**NRC ADVANCED MANUFACTURING PROGRAM (AMP)
WINNIPEG, MB****ISSUED BY**

Addendum No. 4 27

1 WEST ELEVATION 1
DA-098 1 : 100

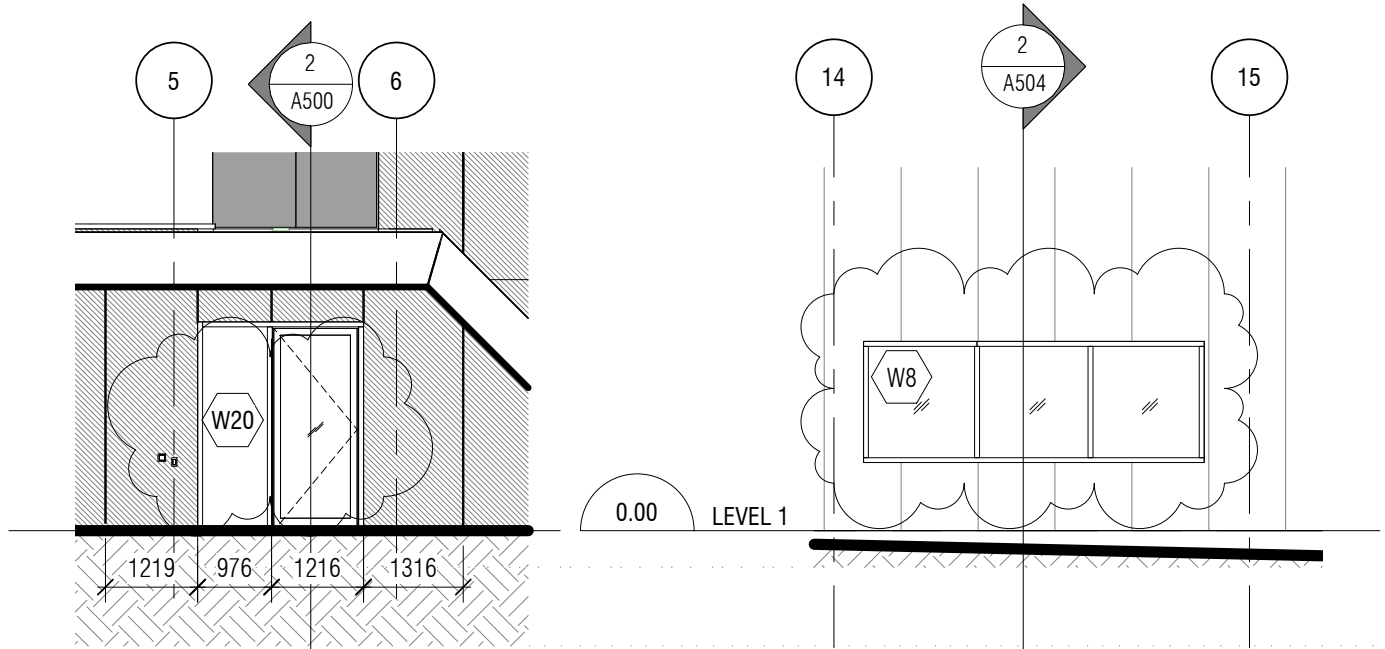
4.1 Refer to A301 – East and West Elevation:

.1 Refer to Detail 2 – West Elevation;

.1 Locate window tag W20 and W8 as indicated in the attached detail sheet, DA-098.
